**DOCUMENT 00 91 03  
ADDENDUM NO. 3**

PROJECT: 2024 Smith and Spillane MS Renovations  
BID DATE: **Thursday, February 20, 2025 (no Change)**  
FROM: Carolina Weitzman, A.I.A.  
Natex Corporation Architects  
447 Heights Blvd, Houston, TX 77007  
TO: **Prospective Bidders**

**TECHNOLOGY FIRST FLOOR PLAN - AREA 'C'**  
**T2.03**

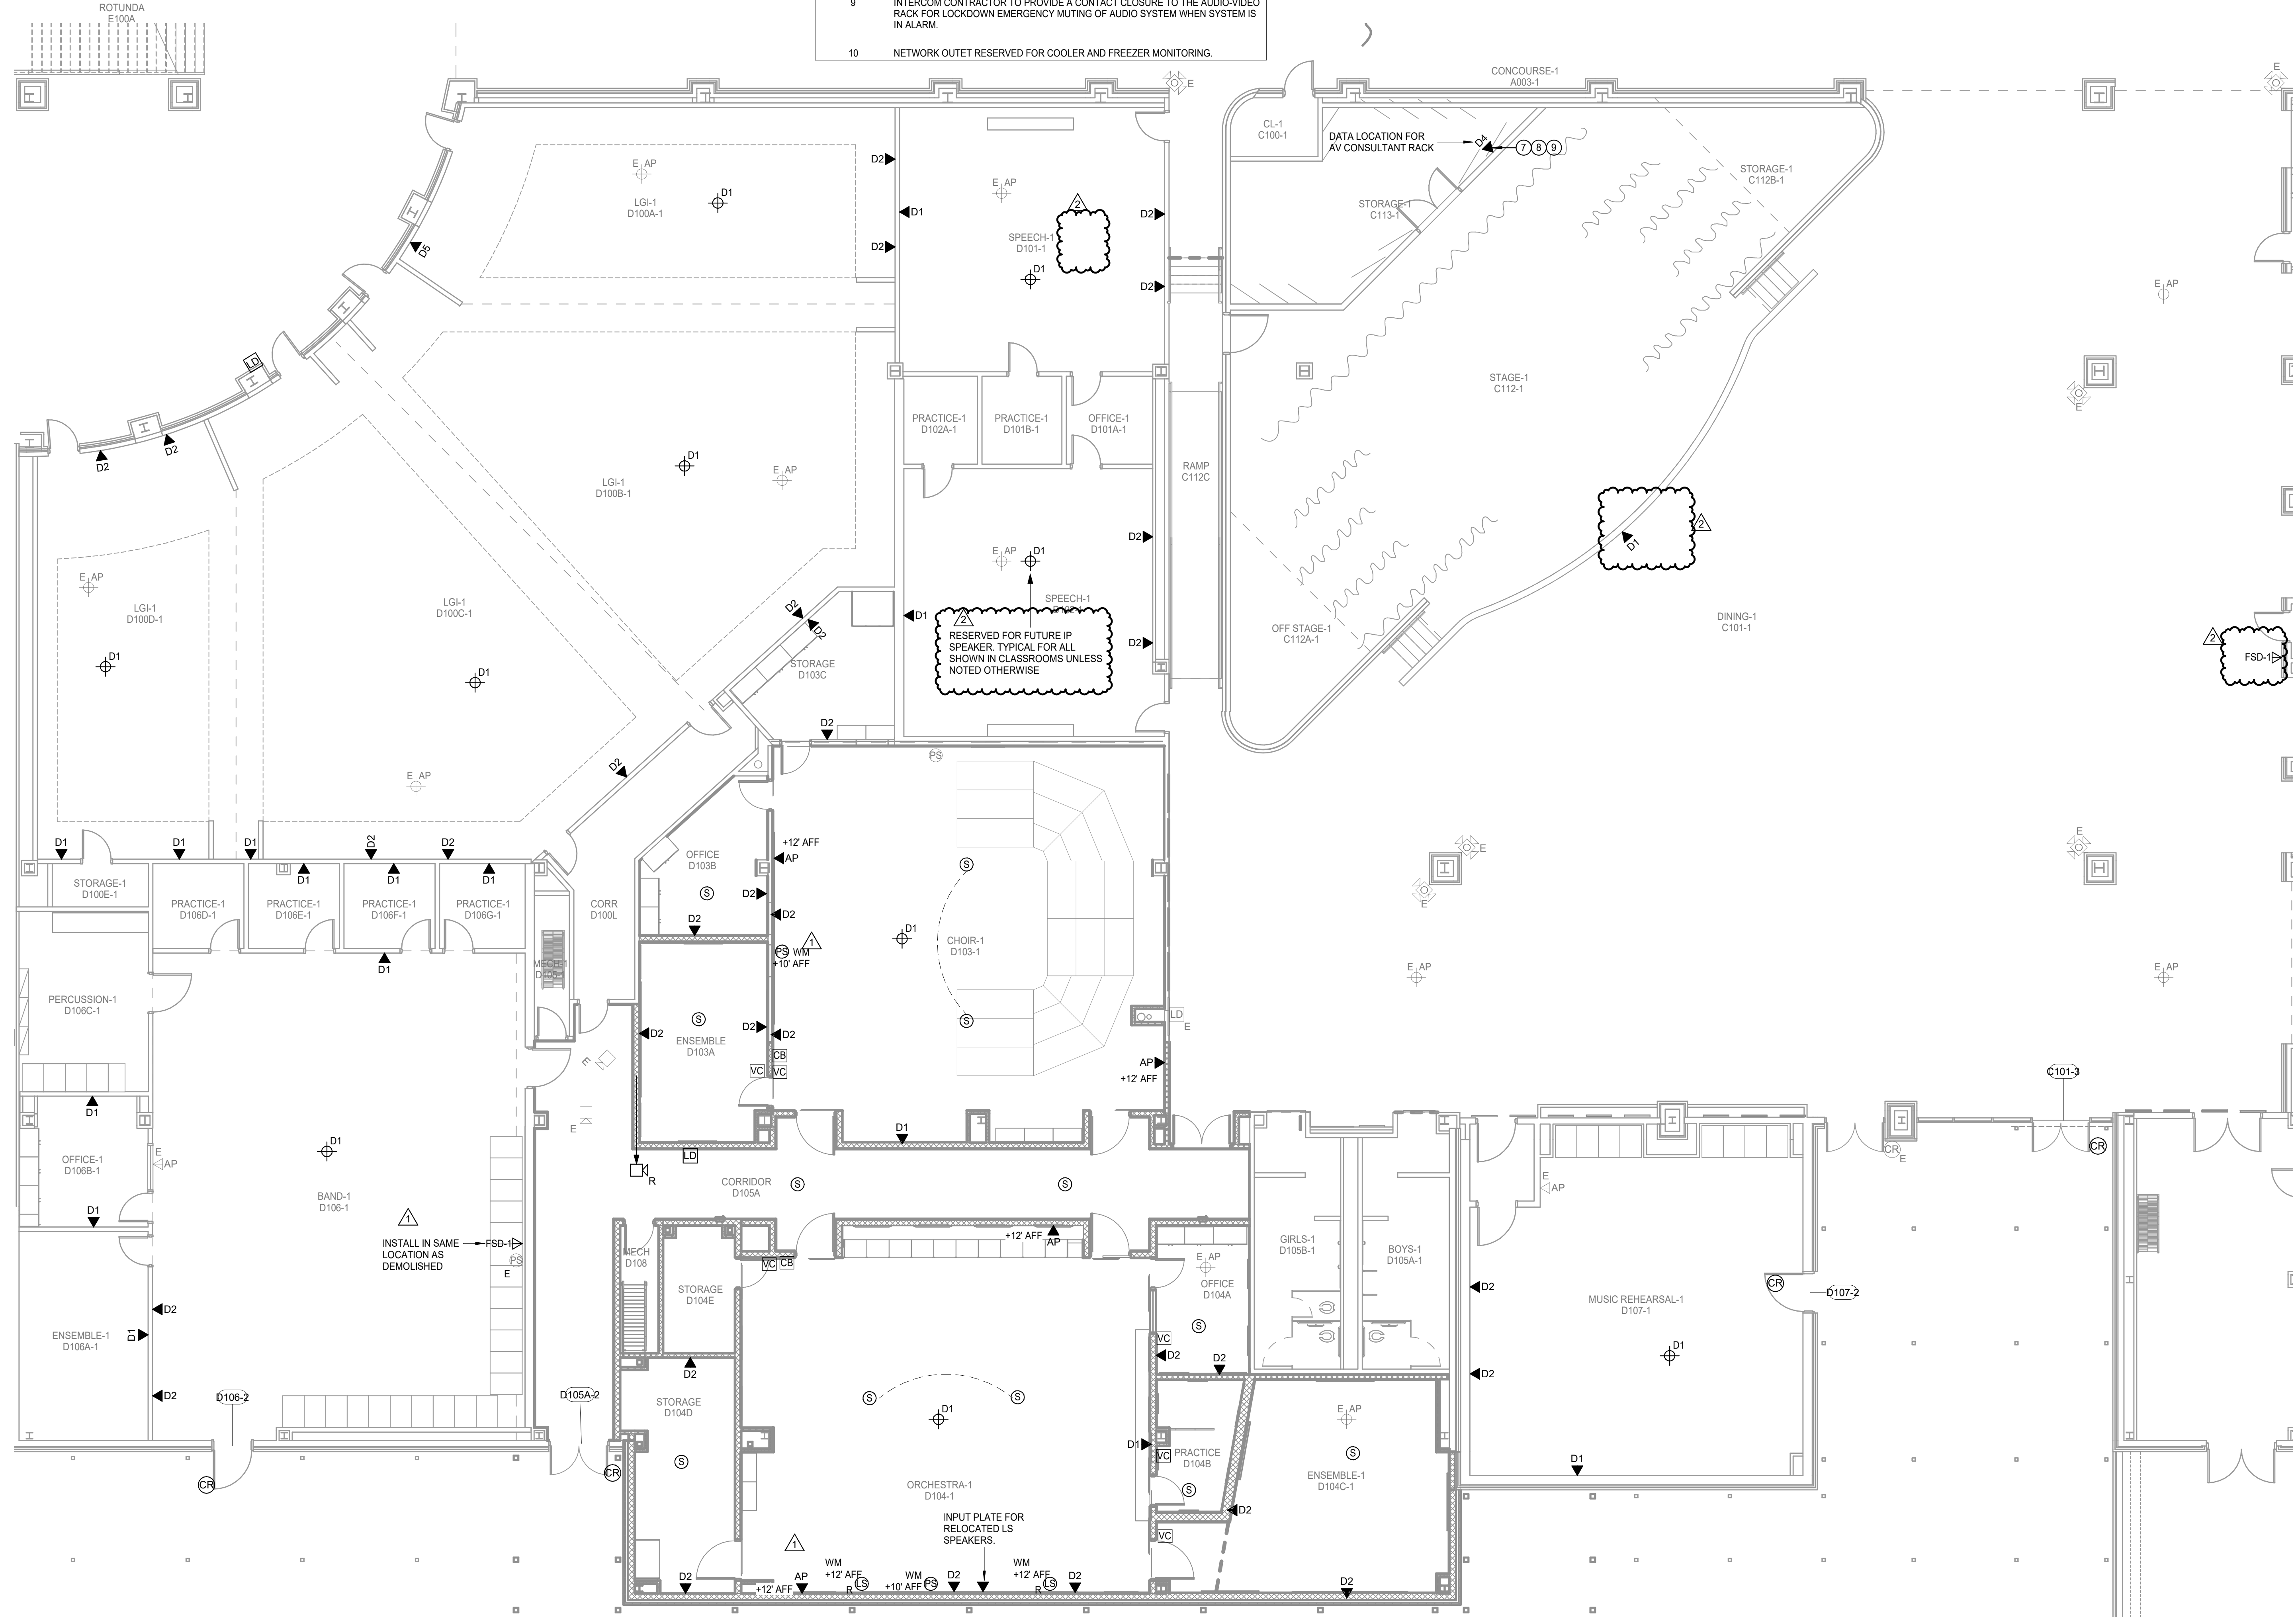
- a. Refer to revised plan for fire alarm remote power supply locations.
30. T2.03 – TECHNOLOGY FIRST FLOOR PLAN – AREA 'C'
  - a. Refer to revised plan for additional drop location and ceiling drop clarification.

**TECHNOLOGY FIRST FLOOR PLAN - AREA 'E'**  
**T2.05**

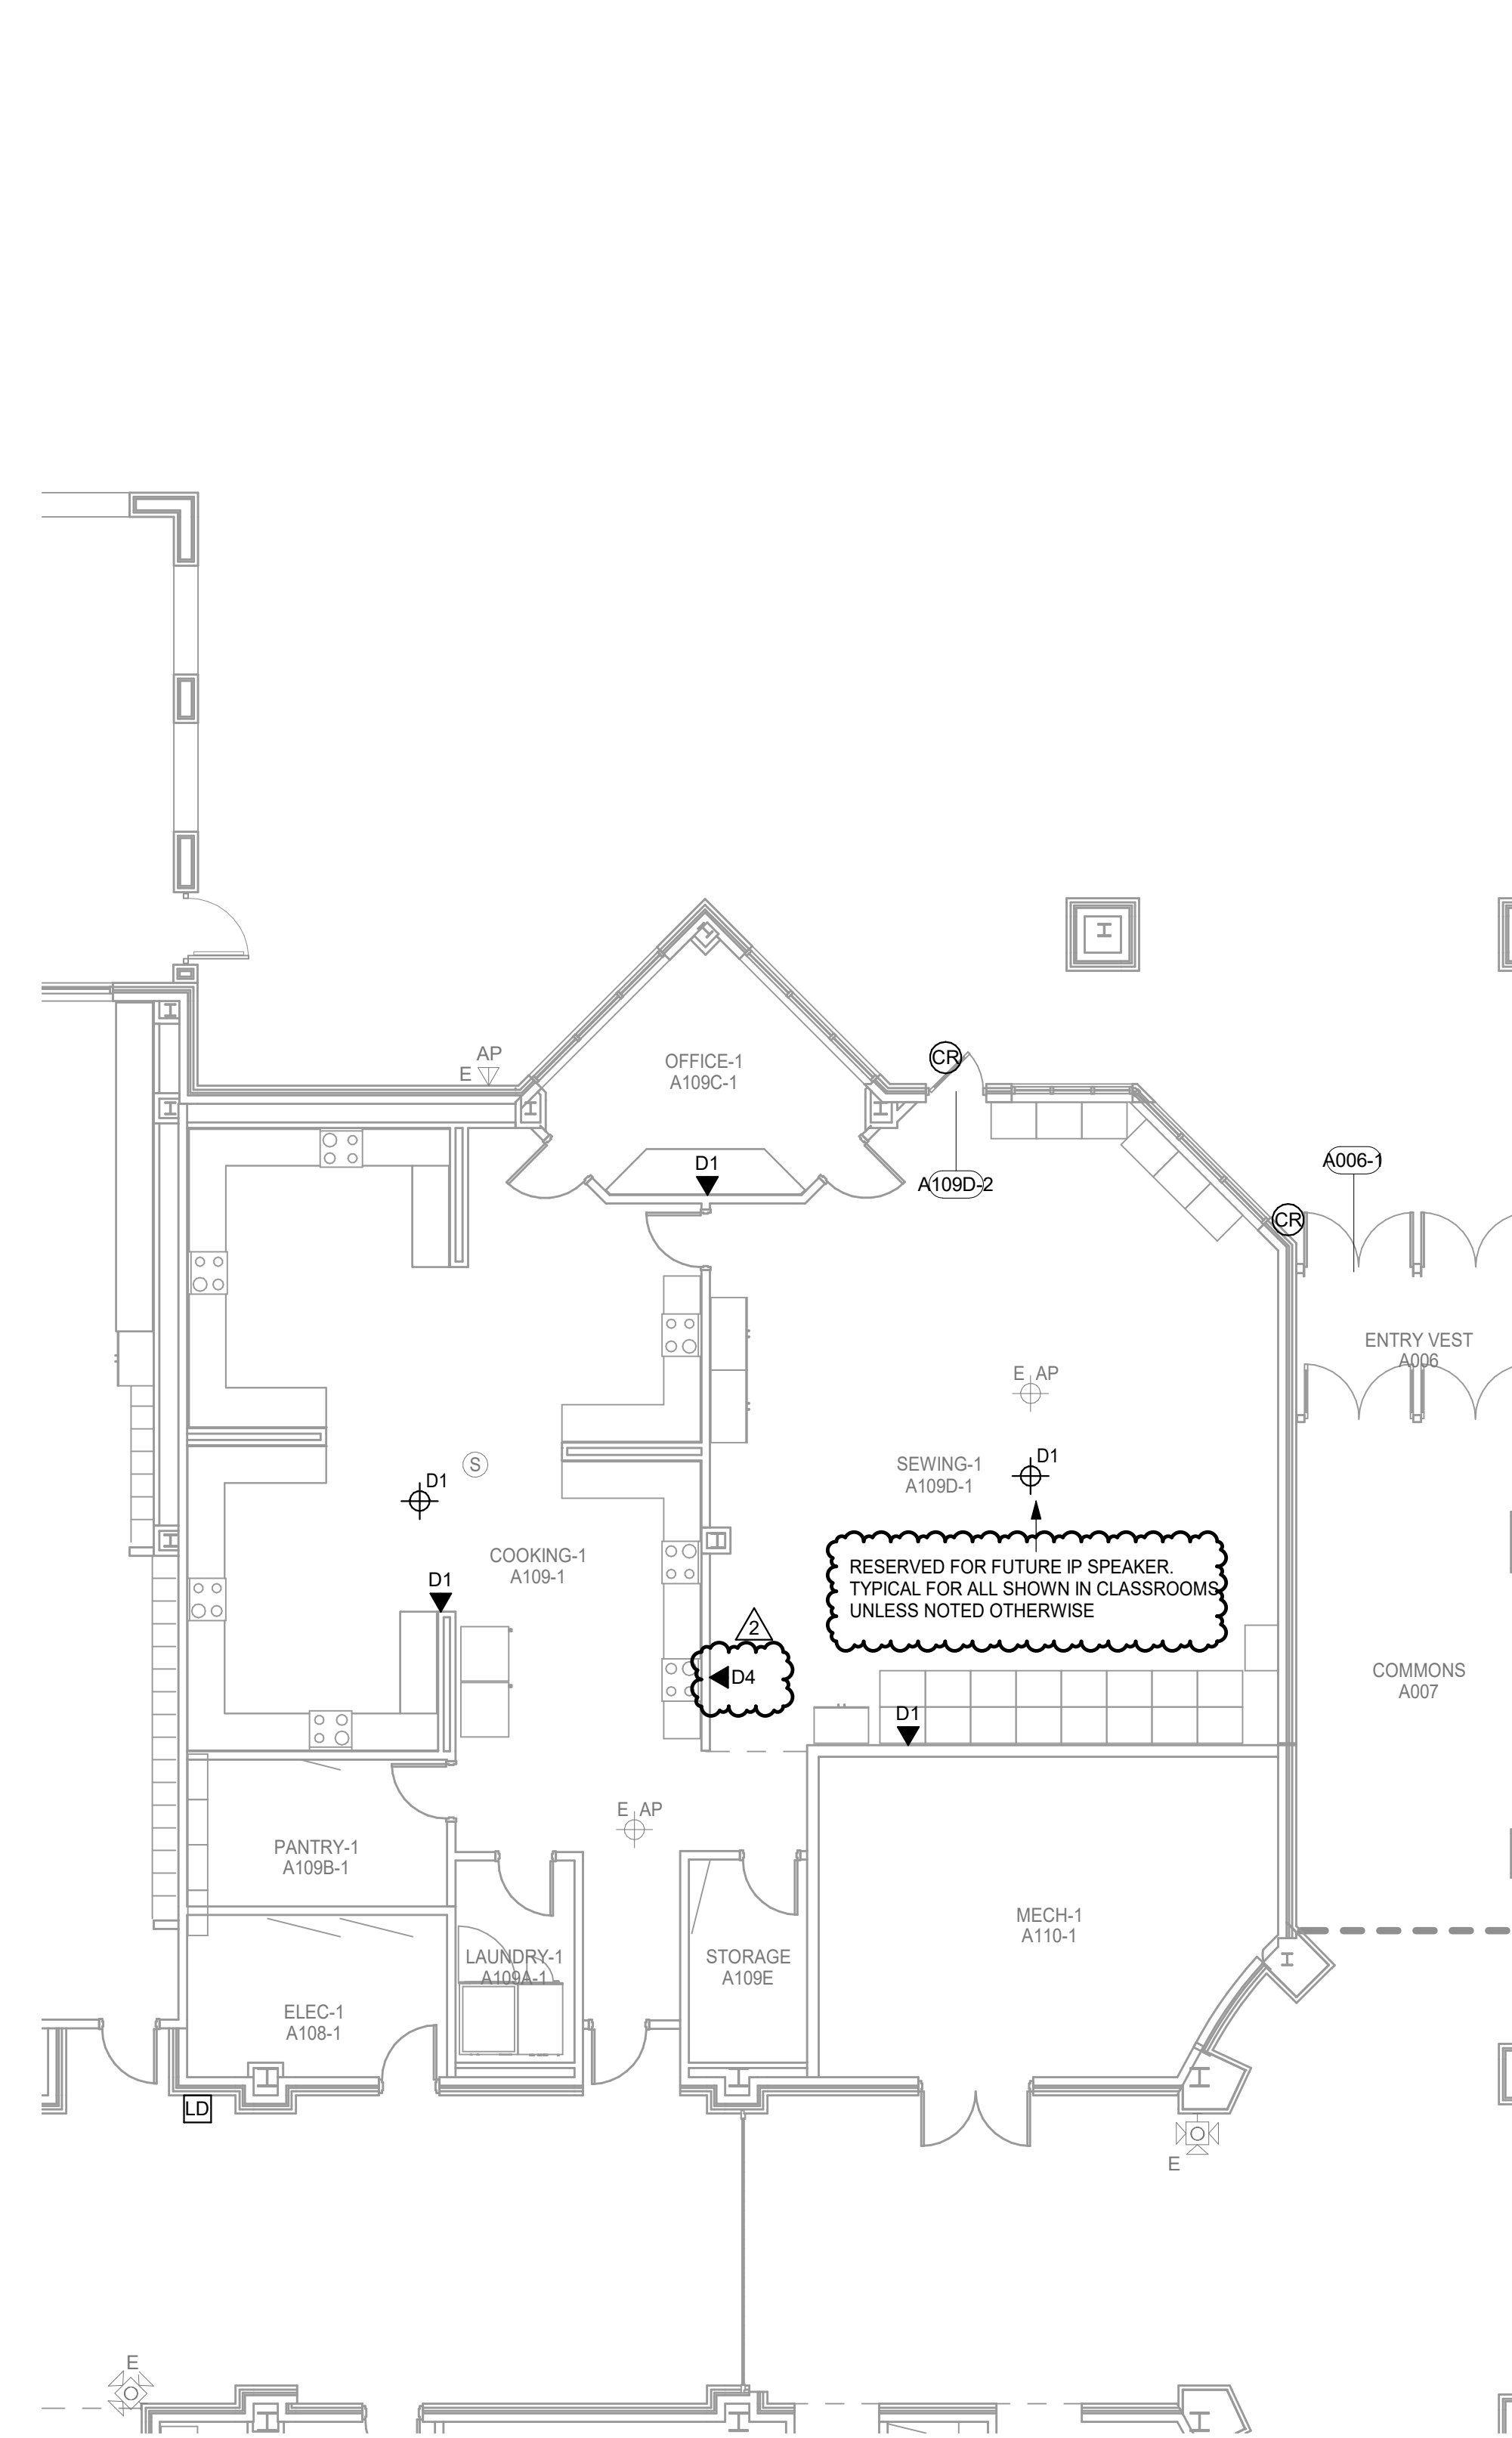
31. T2.04 – TECHNOLOGY FIRST FLOOR PLAN – AREA 'D'
  - a. Refer to revised plan for additional drop locations and ceiling drop clarification.
32. T2.05 – TECHNOLOGY FIRST FLOOR PLAN – AREA 'E'

- a. Refer to revised plan for additional drop location and ceiling drop clarification.
